Access Compliance Report

Public Rights-of-Way

Intersection ID: 23808	Main Street: LONGLEAF_DR	Cross Street: N/A	Location: SW
ADA ID: 6E6F46685BF0	Ramp Type: PerpDiag	Initial Pass/Fail: Fail	Overall Compliance: No
		Severity Score: 25

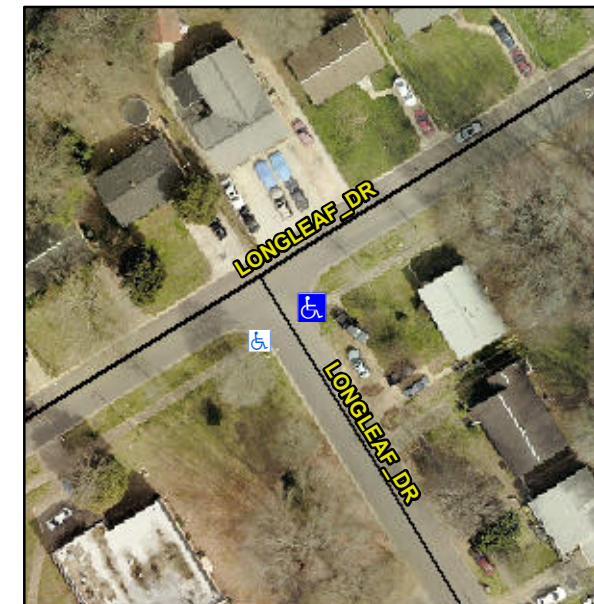
Not Found, R304.5.3

Compliance	Description	Data	Compliance	Description	Data
N/A	Ramp Length (in)	72.0	Yes	Ramp Slope (%)	5.8
Yes	Ramp Width (in)	56.0	No	Ramp XSlope (%)	8.9
N/A	Flare Type LT	N/A	N/A	Flare Type RT	N/A
N/A	Flare Slope LT (%)	N/A	N/A	Flare Slope RT (%)	N/A
N/A	Flare Traversable LT?	N/A	N/A	Flare Traversable RT?	N/A
N/A	Landing Length (in)	N/A	N/A	DWS Provided?	N/A
N/A	Landing Width (in)	N/A	N/A	DWS Contrast?	N/A
N/A	Landing Slope (%)	N/A	N/A	DWS Length (in)	N/A
N/A	Landing X Slope (%)	N/A	N/A	DWS Full Width?	N/A
N/A	Landing Curb? (Y/N)	N/A	N/A	DWS Offset (in)	N/A
N/A	Shared Landing?	N/A			
N/A	Gutter Ponding?	N/A	N/A	Gutter Slope (%)	N/A
N/A	Gutter Lip Ht (in)	N/A	N/A	Gutter X Slope (%)	N/A
N/A	Painted X Walk1?	No	N/A	Painted X Walk2?	No
	X Walk 1 Direction	To N		X Walk 2 Direction	To E
N/A	X Walk 1 Width (in)	N/A	N/A	X Walk 2 Width (in)	N/A
	X Walk 1 Slope (%)	6.2		X Walk 2 Slope (%)	0.1
	X Walk 1 X Slope (%)	5.8		X Walk 2 X Slope (%)	5.9

Remove & Replace Curb Ramp With Two New Directional Ramps or Equivalent.
